U. S. NUCLEAR REGULATORY COMMISSION
REGION I

Report No. 50-244/91-80
Docket No. 50-244
License No. DPR-18
Licensee: Rochester Gas and Electric Corporation
89 East Avenue
Rochester, New York 14649
Facility Name: Ginna Nuclear Power Station
Inspection Conducted: May 6 through June 7, 1991
Inspection Team L. Cheung, Team Leader, RI
J. Lara, Reactor Engineer, RI
R. Mathew, Assistant Team Leader, RI
NRC Consultants: M. Goel, Mechanical Engineering, AECL
S. Inamdar, Electrical Engineer, AECL
J. Leivo, Leivo Associates

Inspection Summary: Inspection on May 6 through June 7, 1991
Report No. 50-244/91-80

Areas Inspected: Announced team inspection by regional and contract personnel
to review the functionality of the electrical distribution system.

ATTACHMENT 2 - GINNA ELECTRICAL DISTRIBUTION SYSTEM

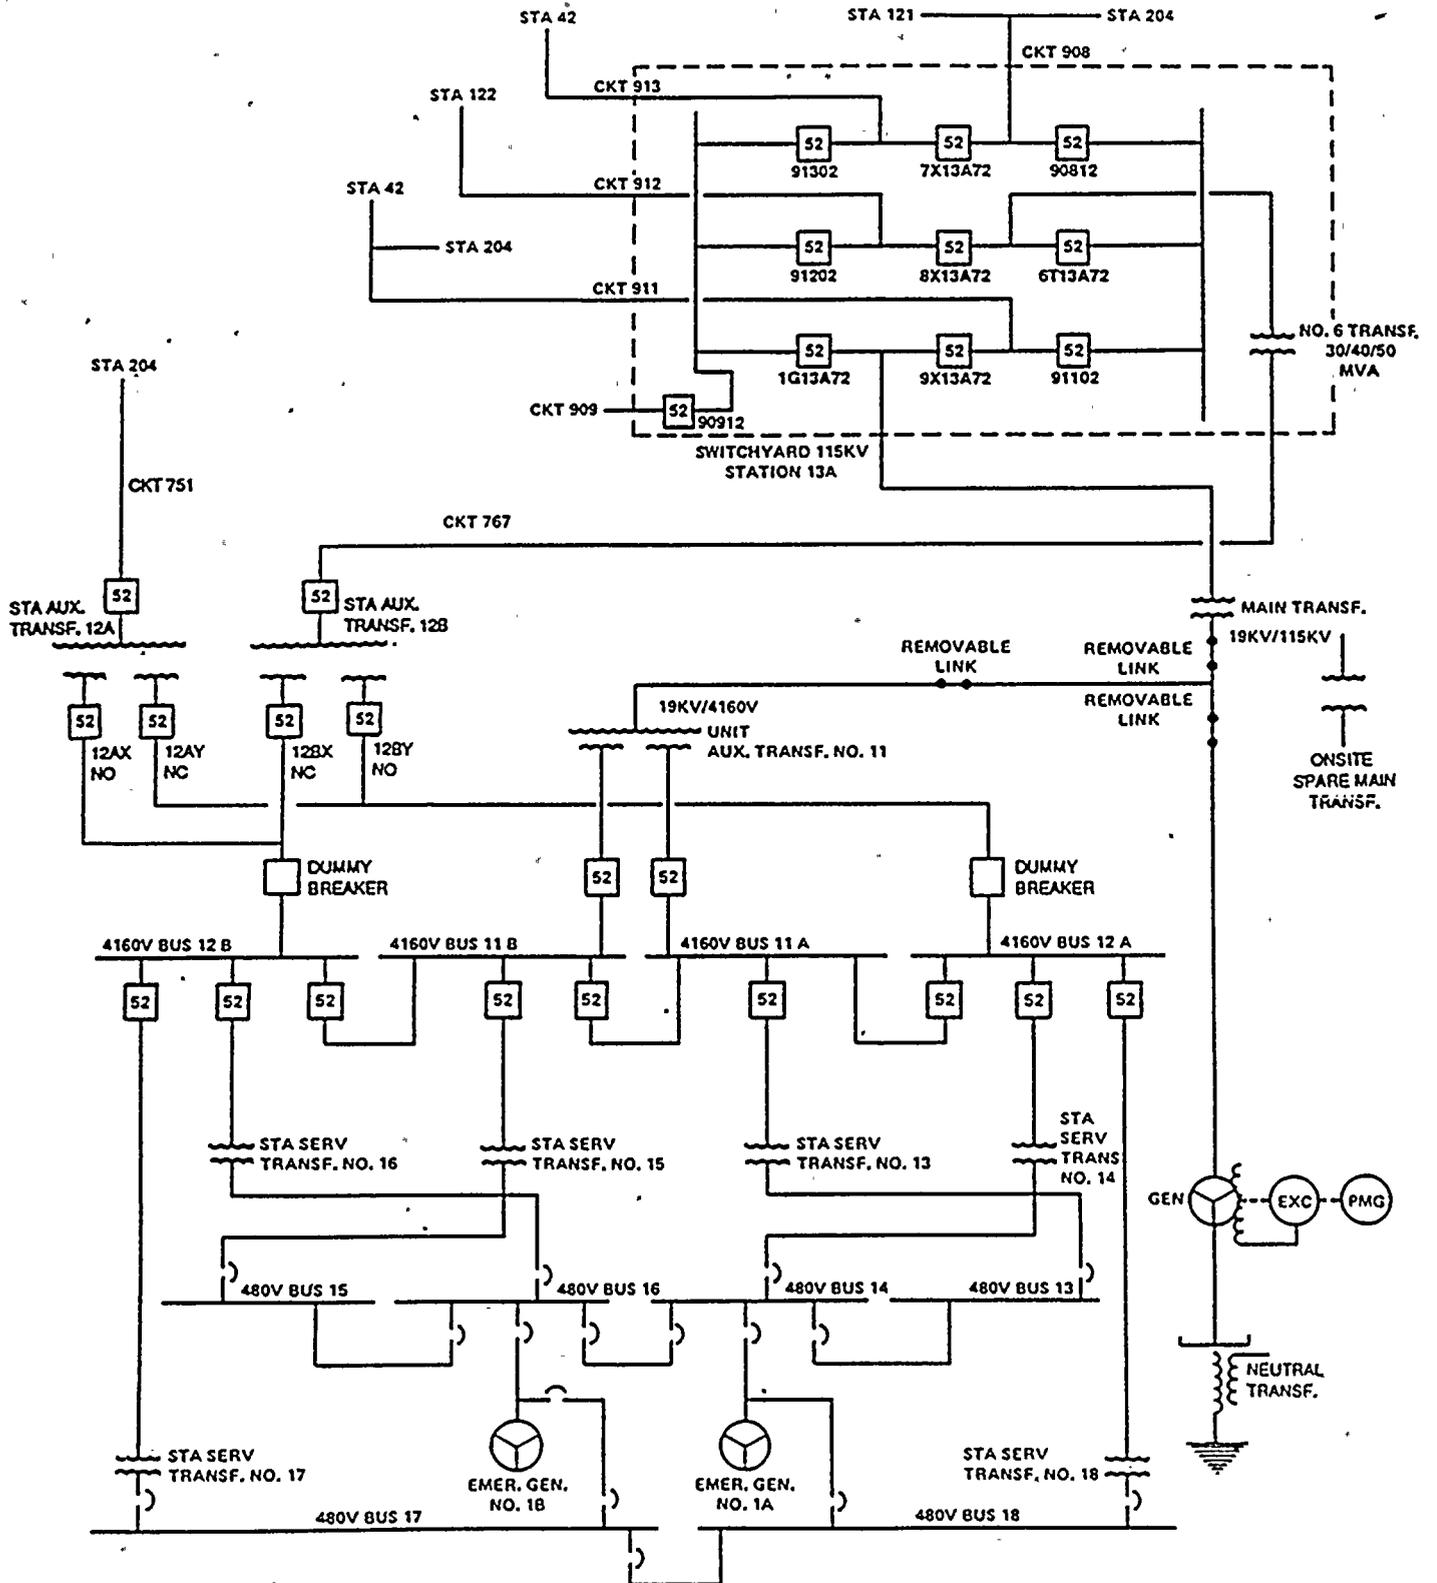
The team reviewed the AC Electrical System One Line Diagram, Drawing Number 33013-2409 and found that the two cables feeding 480 V buses 14 and 18 were directly connected to the EDG without any protection. The team was concerned with the potential for a fault at the end of the unprotected long greenhouse feeder cables since the cables are buried underground and are susceptible to water exposure. Normally such cables are prone to faults and a fault could remain undetected for a long period of time. If a ground fault develops, it can cause the loss of two emergency buses. The licensee stated that these cables have not been a problem. Furthermore these cables are meggered annually per procedure M15.1. The team observed that a fault could occur between the testing periods.

The licensee responded by stating that the monthly test procedures PT 12.1 and PT 12.2 require the Unit/Parallel switch be placed in the "Unit" mode prior to procedure completion. The team had no further questions.
